ADDENDUM NO. 1

Project Name:	Charlottesville-Albemarle Airport Mechanical Systems Upgrades
RS&H Project Number:	20541892009

DATE OF ISSUANCE: June 28, 2024

PROJECT STATUS:
 ISSUED FOR BID

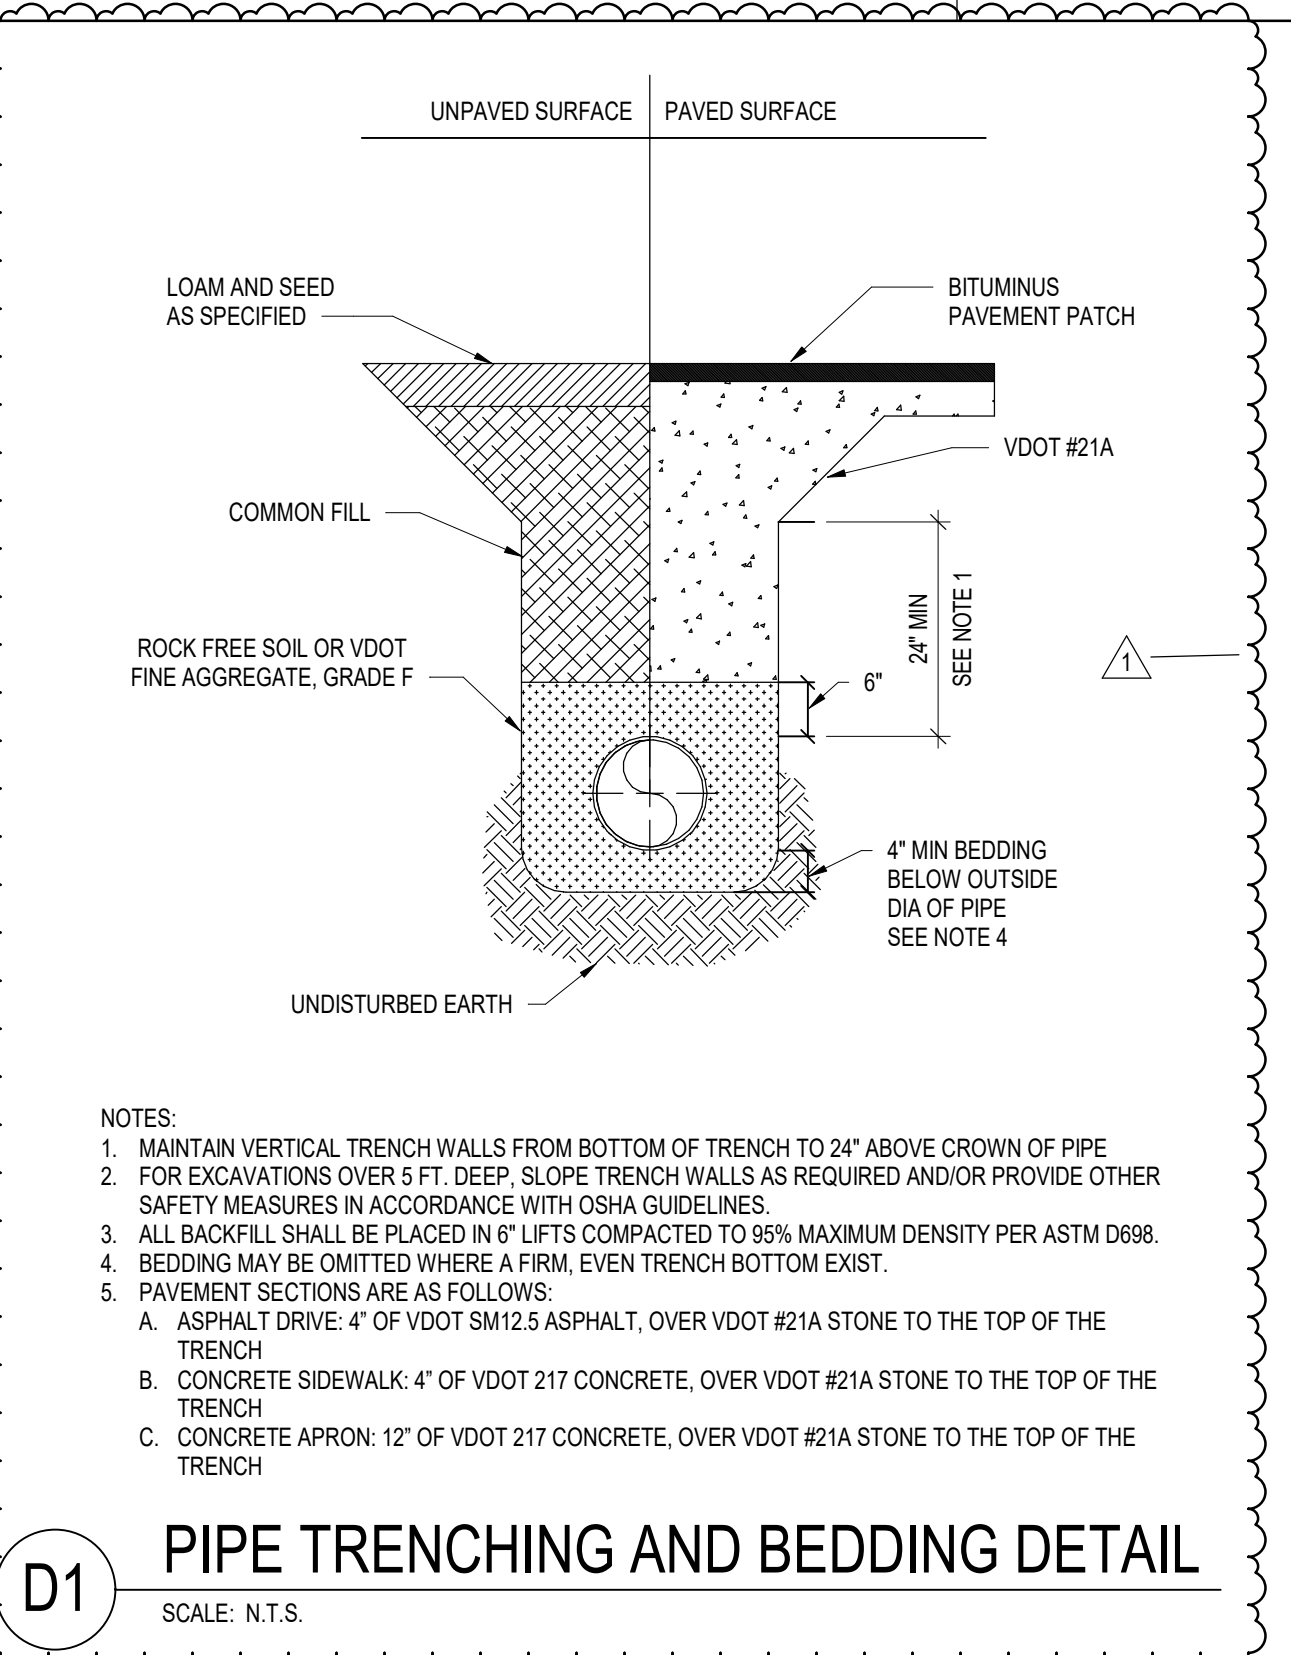
13	Drawing MS101 – Detail #1 – Shows pipe trench detail, we also need the thickness required to patch the asphalt drive, concrete walkway, and concrete apron. Also, the requirements, if any, for re-bar.	Pavement sections are as follows: a. Asphalt Drive: 4” of VDOT SM12.5 asphalt, over VDOT #21A stone to the top of the trench b. Concrete Sidewalk: 4” of VDOT 217 concrete, over VDOT #21A stone to the top of the trench c. Concrete Apron: 12” of VDOT 217 concrete, over VDOT #21A stone to the top of the trench
14	Drawing M501 – Detail A5 Air Separator, and Detail A3 Expansion Tank (ET-1), are these items existing to remain, or new? If so, where are they located, and where are the tie in locations? Also, we need a schedule for these items, listing Capacity, Size, Basis of Design etc... And do they receive insulation?	Details were applicable to a previous scope of work that has been removed. Details have been deleted. See revision in Addendum #1.

50	Would it be possible to get a little more detail on exactly where the gas line is running? Particularly on the one that runs directly towards the building before cutting to the right. For example, if it's running under the existing sidewalk and where exactly it goes into the building.	Site plan on MS101 has been updated to show pipe routing and surrounding pavement and utilities. See revision in Addendum #1.
51		
52

SHEET ID:
M501

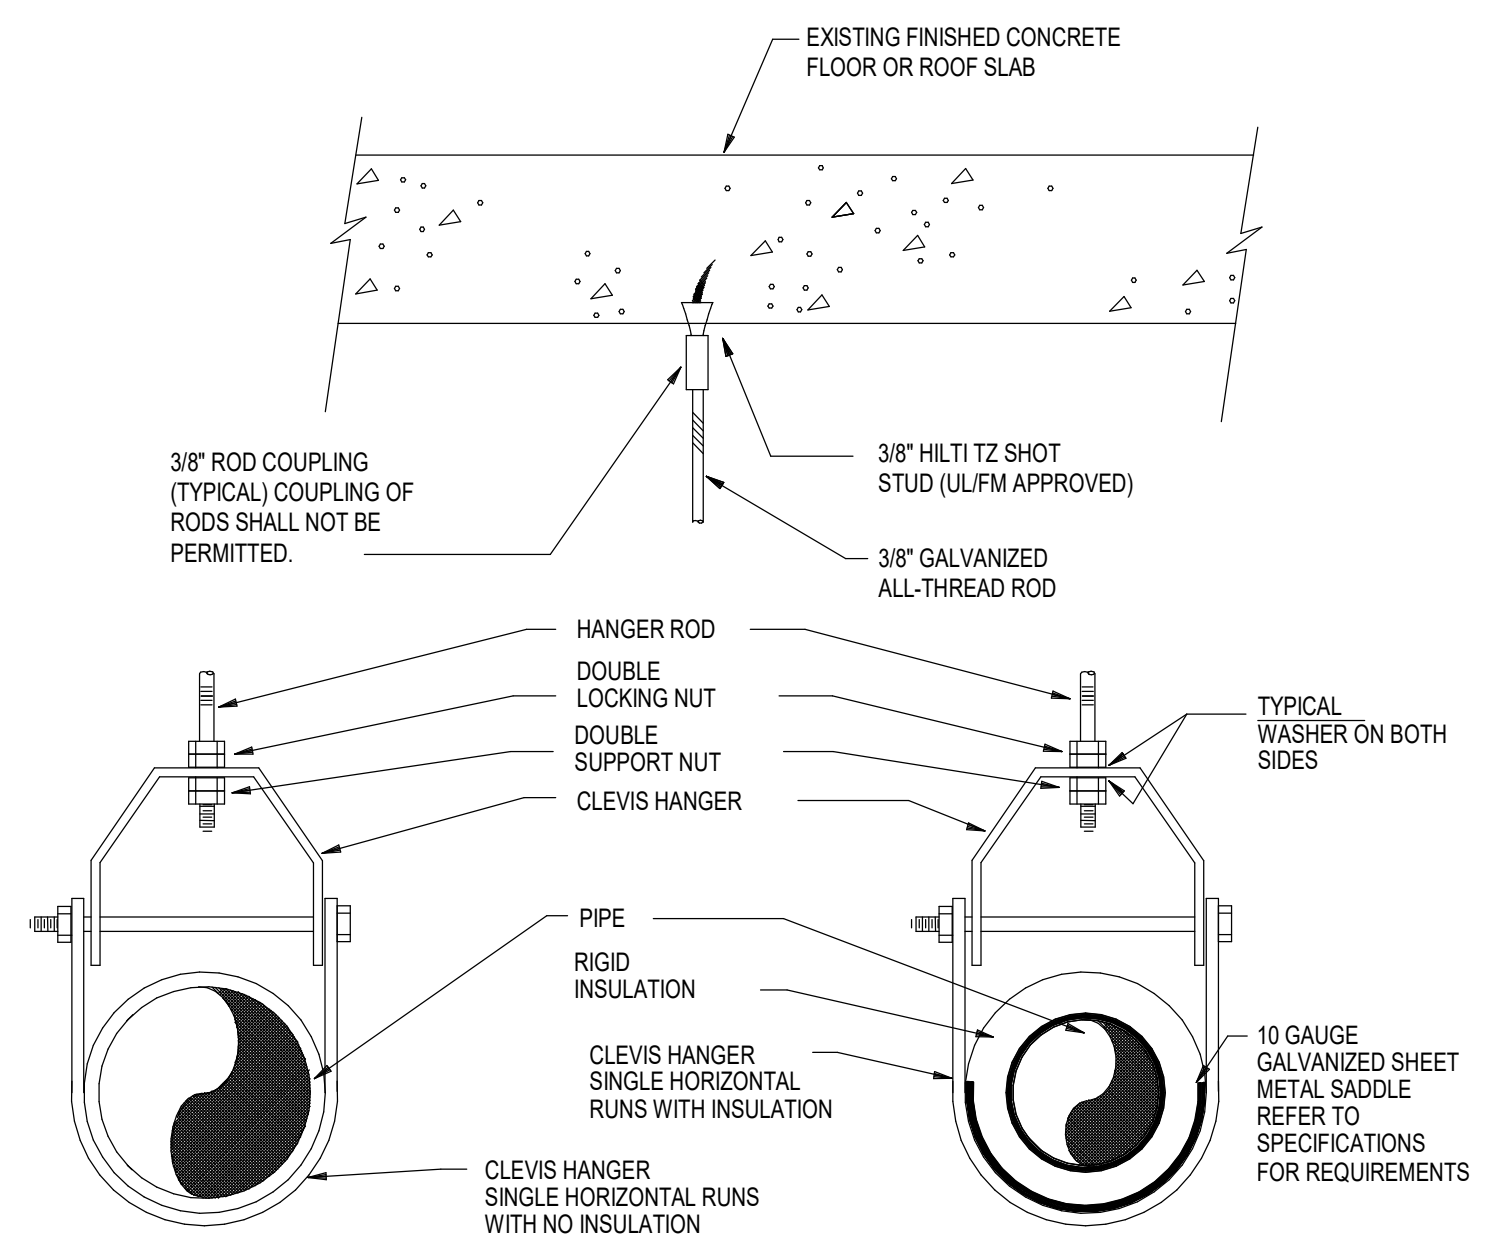
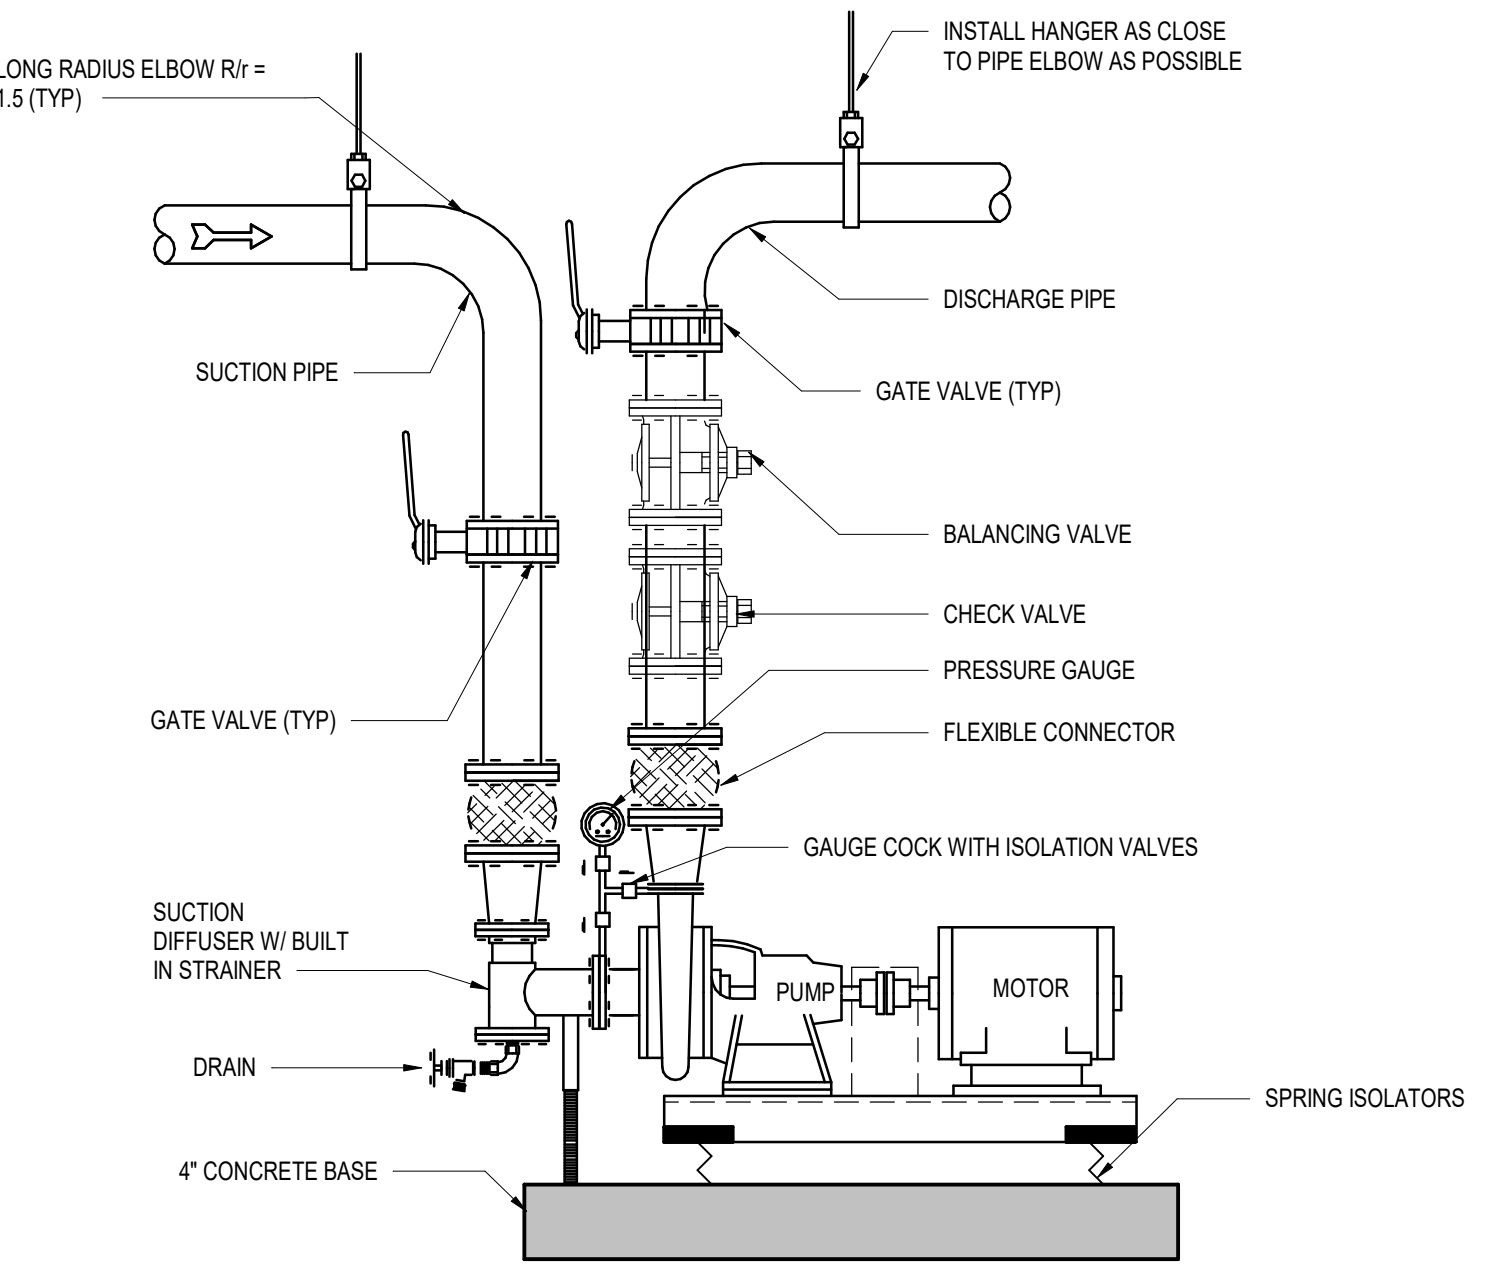
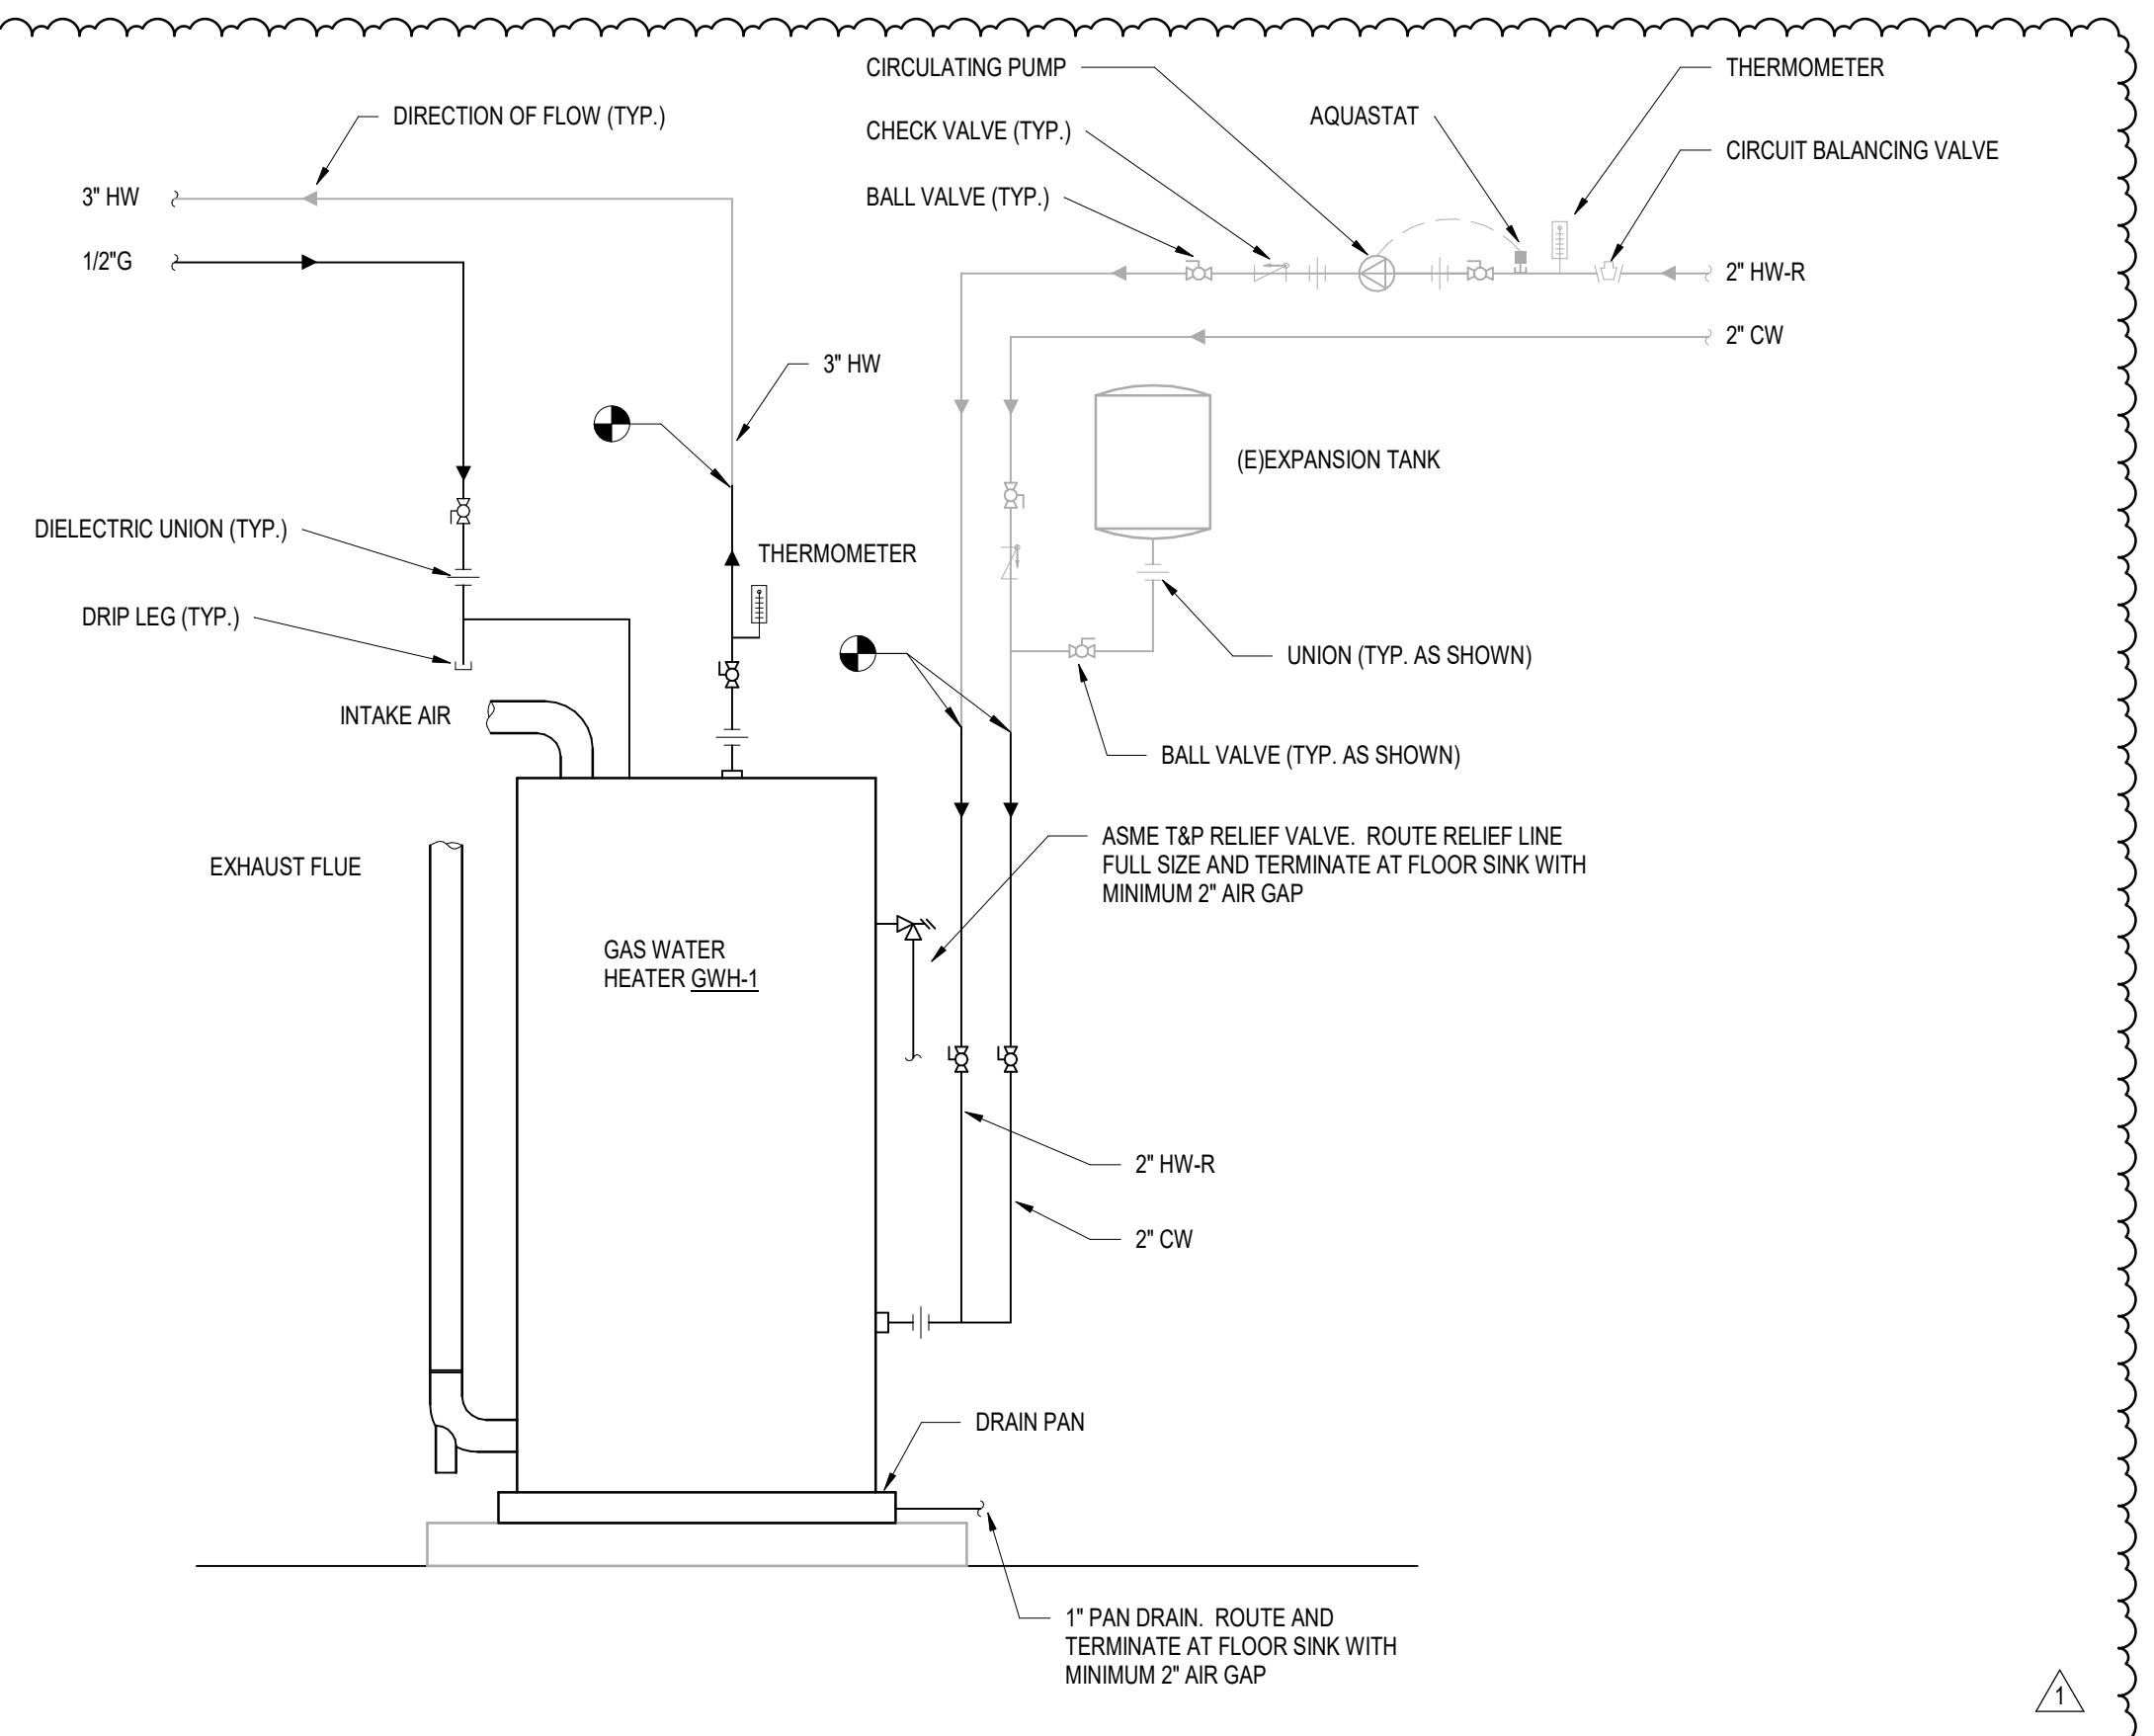
15	Drawing M501 – Detail A3 calls for a “Pressure Relief Valve”, and “Backflow Preventor”, are these existing to remain, or new? If new please provide specifications.	Details were applicable to a previous scope of work that has been removed. Details have been deleted. See revision in Addendum #1.
16	Drawing M501 – Detail B3 shows a “Aquastat”, “Circulating Pump”, and “Balancing Valve” are these items existing to remain, or new? If new please provide specification.	Details were applicable to a previous scope of work that has been removed. Details have been deleted. See revision in Addendum #1.
17	Drawing M501 – Detail A1 shows a “Balancing Valve”, and “Check Valve”, we have not found a specification for these items, please provide.	Details were applicable to a previous scope of work that has been removed. Details have been deleted. See revision in Addendum #1.
18	Drawing M801 shows “Setter”, “Balancing, Butterfly, and Check Valves” we have not found a specification in Division 23 for these items, are they existing to remain? If not please provide specification.	Setters and other valving not applicable for controls diagram. See revision in Addendum #1.
